Your Reference: SSD 15_7372
Our Reference: NCA/4/2016
Contact: Myfanwy McNally
Telephone: 9806 5447

Re: New O'Connell Street Public School at 3 Marist Place & 24 O'Connell Street, PARRAMATTA NSW 2150

The City of Parramatta Council would like to raise the following concerns with the information currently provided as part of the application.

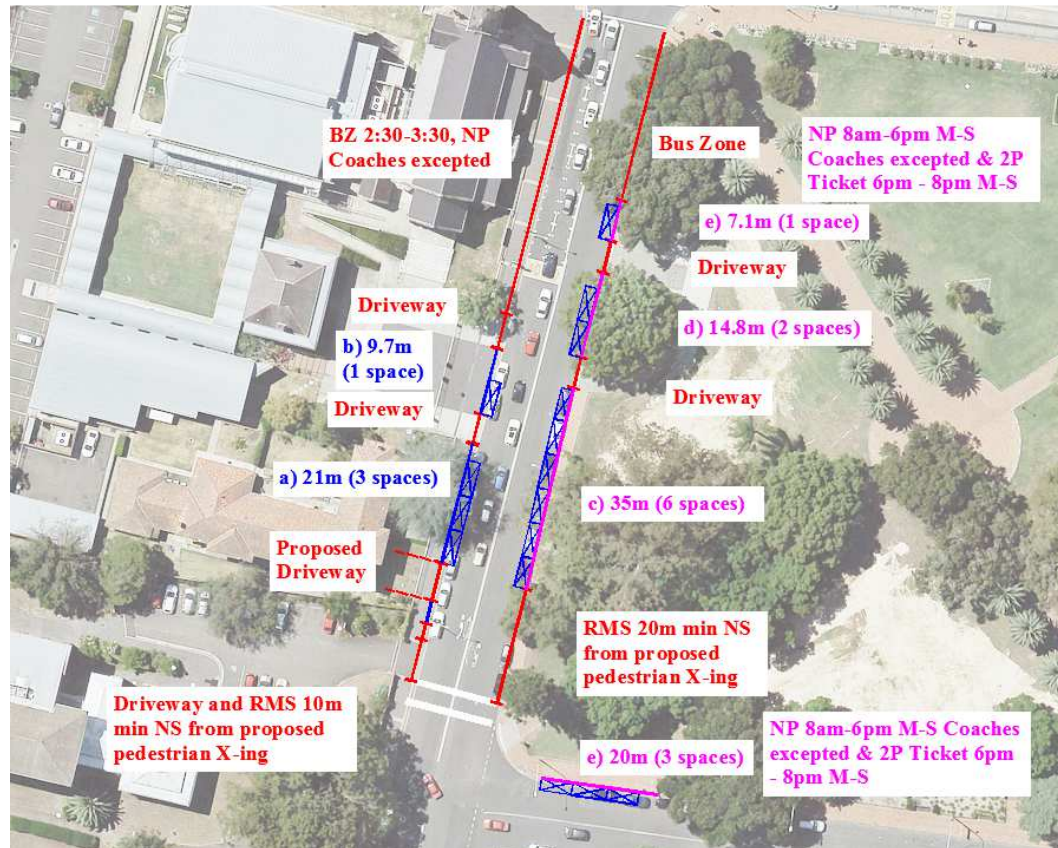
Discounting the driveways, the bus zone and RMS no-stopping requirements regarding the proposed pedestrian crossing, the total available set-down/pick-up parking for the current proposal is **16 spaces** (see figure below) rather than the 35 in the applicant's report¹.

The results of the site visit and use of more conservative assumptions shows a likelihood of significant parking demand within the proposed set-down / pick-up area, which contains just 16 potential spaces (not the 35 in the applicant's report). Although the proposed alteration of parking restrictions in the area to allow for pick-up and set-down of students is supported, these results show there is not enough potential on-street parking available within the area shown in the application to accommodate the demands of the development. The high demand and shortage of on-street parking spaces will result in significant traffic flows that are not likely to be accommodated in the area, particularly in the afternoon. It is recommended that additional measures beyond what is proposed in the Traffic Report are provided to accommodate and/or mitigate the demand for pick-up/set-down parking.

The addition of 'No Parking 8am – 9:30am & 2:30pm – 4:00pm School Days' restrictions to the 16 available on-street parking spaces shown in the above figure, to encourage pick up and set down of students, is supported. Such changes will be required to be approved via Parramatta Traffic Committee (PTC) prior to the commencement of any related works. Pending PTC approval signs are to be installed to Council requirements at no cost to Council.
